Wisconsin Department of Transportation

Proposal #24: 6414-00-79, WISC 2021 182
Village of Plover, Post Road
Springville Drive to Tommy's
Turnpike
Business 51
Portage County

This is Addendum No. 01, which provides for the following:

ADDENDUM NO. 01
6414-00-79 & 6414-00-89
January 28, 2021

Addendum No. 01
ID 6414-00-79
Revised Sheet 110
January 28, 2021

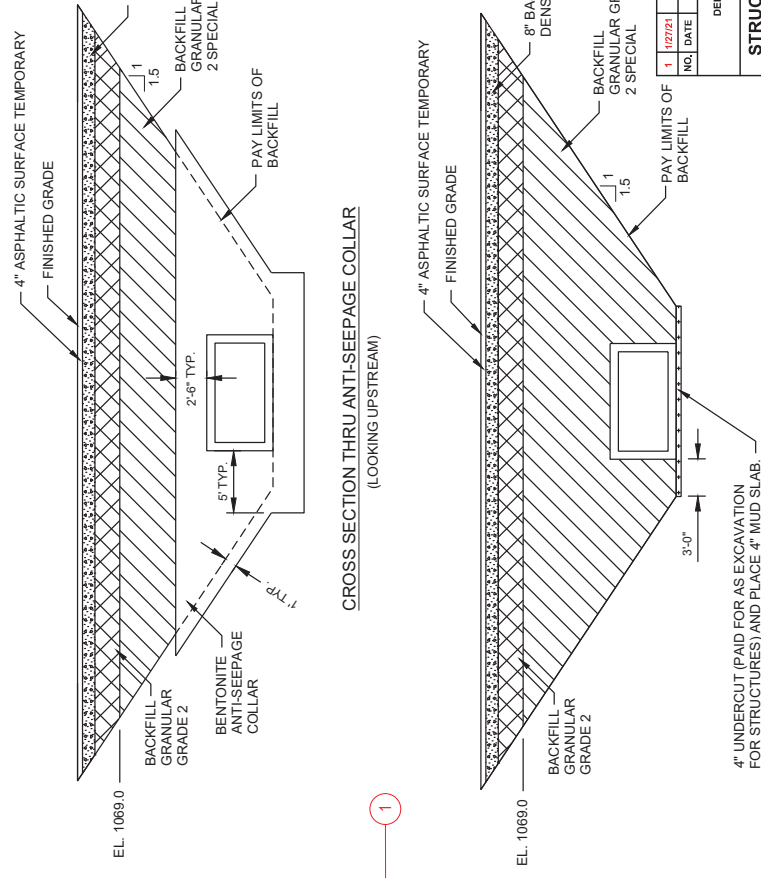
Revised Plan Sheets	
Plan Sheet	Plan Sheet Title (brief description of changes to sheet)
110	Added Clearing and Grubbing items to miscellaneous quantities sheet
286	Revised the "Total Estimated Quantities" table to remove SPV.0105.08
290	Revised the "Detail at Stop Log Slot" to define material for the stop log slot and remove "Hot Dip Galvanized" from steel reinforcement label.

DETAIL AT STOP LOG SLOT

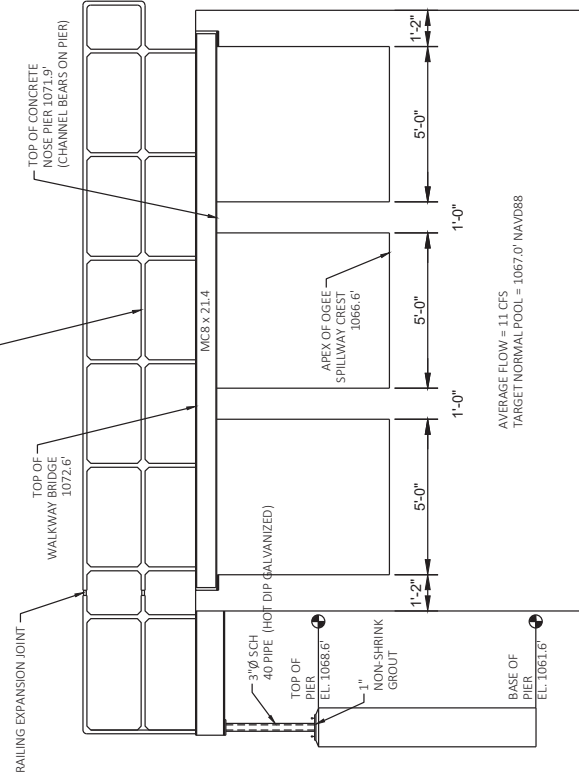
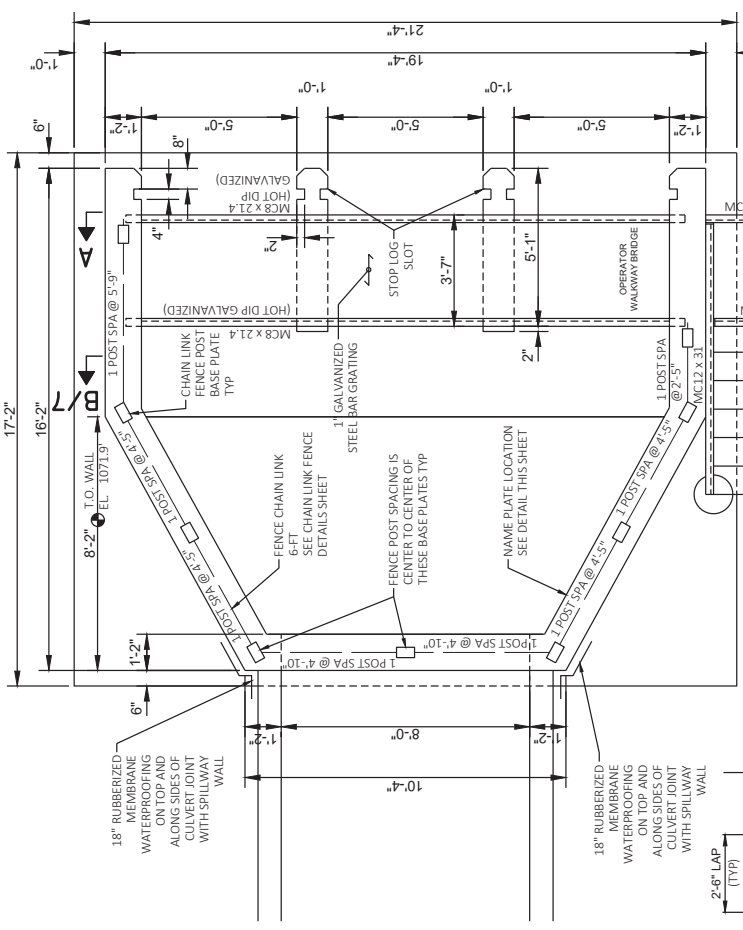
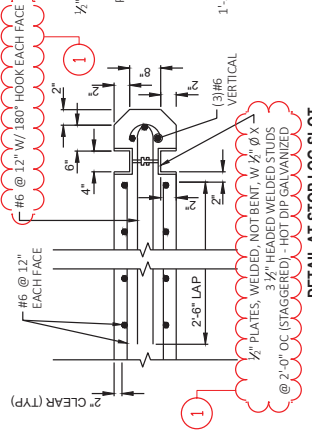
NO.	DATE	REVISION	BY
1	1/27/21	REVISED DETAIL AT STOP LOG SLOT	SLE
